**ADDISON AIRPORT
BUILDING REPORT**

Facility Information: **Facility Name:** 4736 Airport Parkway
Facility Contact: Lisa Pyles **Contact Phone:** 972-450-2878

ADDISON AIRPORT - 4736 Airport Parkway

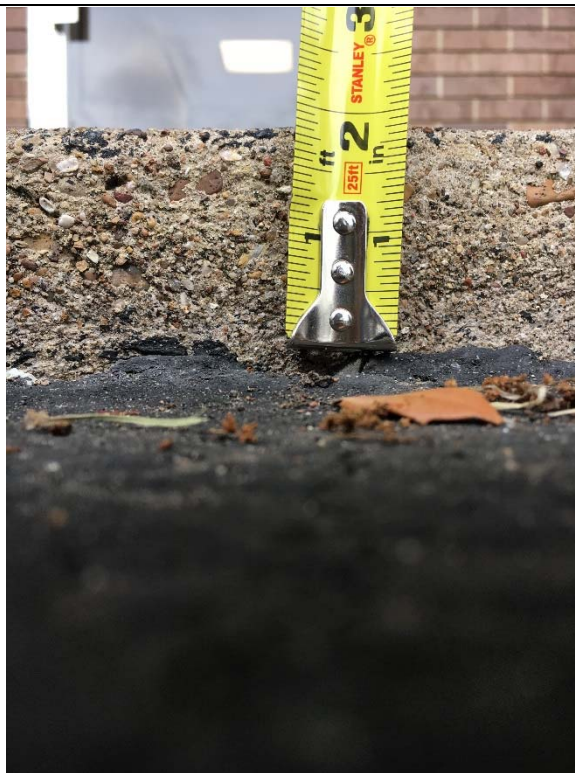
Violation #1: No accessible parking spaces are provided. One accessible parking space is required and it must be van accessible.

Violation #2: There is a 1-13/16" change in level at the main entrance of the building.

Violation #3: The bushes next to the sidewalk along the front of the building protrude into the walkway and reduce the clear width of the path of travel below 36".

There are 6 doors in the facility that have door hardware that requires grasping and twisting to operate.

Violation 1 - There are no accessible parking spaces provided.

Violation 2 - There is a 1-13/16" step to get to the main entrance of the building.

Violation 3 - Bushes provided next to the sidewalk along the front of the building protrude into the walkway and reduce the width of the path of travel.

Violation 4 - There are 6 doors in the facility that have door hardware that requires grasping and twisting to operate.

Provide one van accessible space with required access aisle and signage.

Possible Solutions: Remove change in level at main entrance to the building.

Maintain bushes along the sidewalk to provide 36" minimum clear route.

Replace all knob hardware with lever hardware that doesn't require tight grasping or twisting to operate.

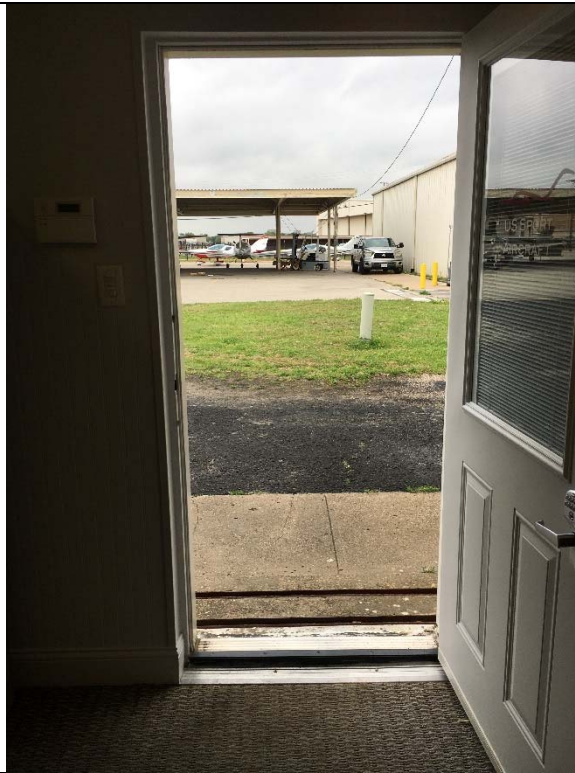
The route leading into the Testing Center requires a 7-5/16" step down to enter.

The exterior exit door from the Testing Center has a 1-1/2" step down.

Violation 5 - The route leading into the Testing Center requires a 7-5/16" step down to enter.

Violation 6 - The route leading outside from the Testing Center has a 1-1/2" step down.

The change in level could be accomplished by installation of a ramp or platform lift. Relocating the functions of the Testing Center to an accessible facility is also acceptable.

Modify door and threshold to be flush with outside surfaces.

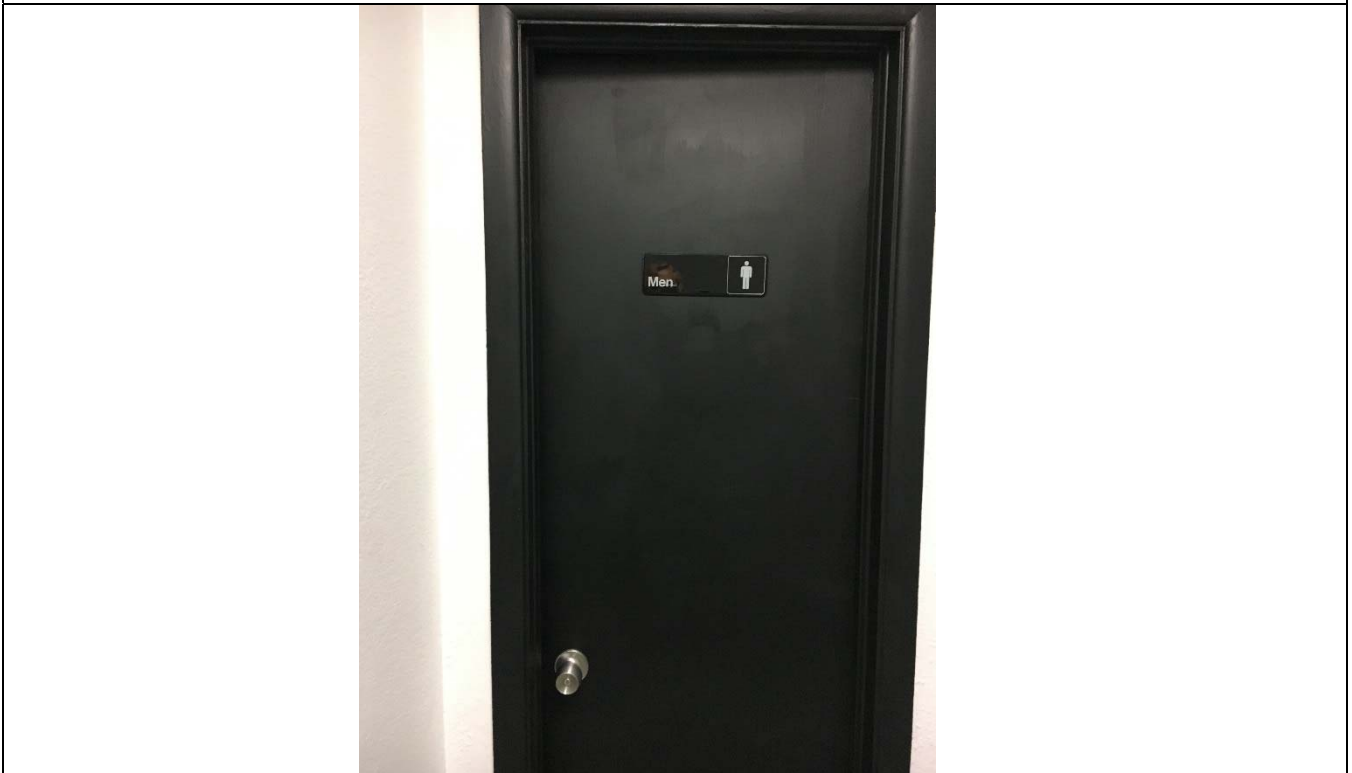
Men's and Women's Restrooms: Signage is mounted on the doors and does not have tactile characters and Braille.

Men's and Women's Restrooms: Door hardware requires grasping and twisting to operate.

Men's and Women's Restrooms: Doors are only 22" wide and do not provide the required 32" minimum clear width.

Violation 7 - Men's and Women's Restrooms: Signage is mounted on the door.

Violation 8 - Men's and Women's Restrooms: Door hardware requires grasping and twisting to operate.

Violation 9 - Men's and Women's Restrooms: Doors are only 22" wide.

Install compliant signage at the men's and women's restroom doors.

Replace knob hardware with lever style door hardware.

Replace doors to achieve 32" minimum clear width and reverse swing of the doors outward.

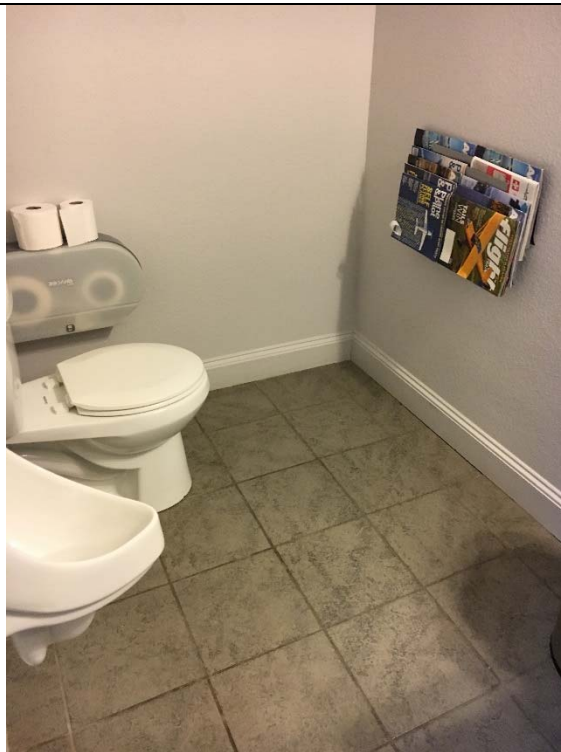
The Women's single user restroom is not large enough to accommodate a wheelchair turning space and the required clear floor spaces for accessible fixtures.

The Men's single user restroom is not large enough to accommodate a wheelchair turning space and the required clear floor spaces for accessible fixtures.

Violation #12: The sink in the breakroom is 36" above finished floor where 34" maximum is required.

Violation 10 - The Women's single user restrooms is not large enough to accommodate a wheelchair turning space.

Violation 11 - The Men's single user restrooms is not large enough to accommodate a wheelchair turning space.

Violation 12 - The counter in the breakroom is at 36" above finished floor.

Enlarge restroom to accommodate accessible water closet and lavatory and wheelchair turning space.

Enlarge restroom to accommodate accessible water closet and lavatory and wheelchair turning space.

Possible Solutions: Modify sink to provide 34" maximum height.
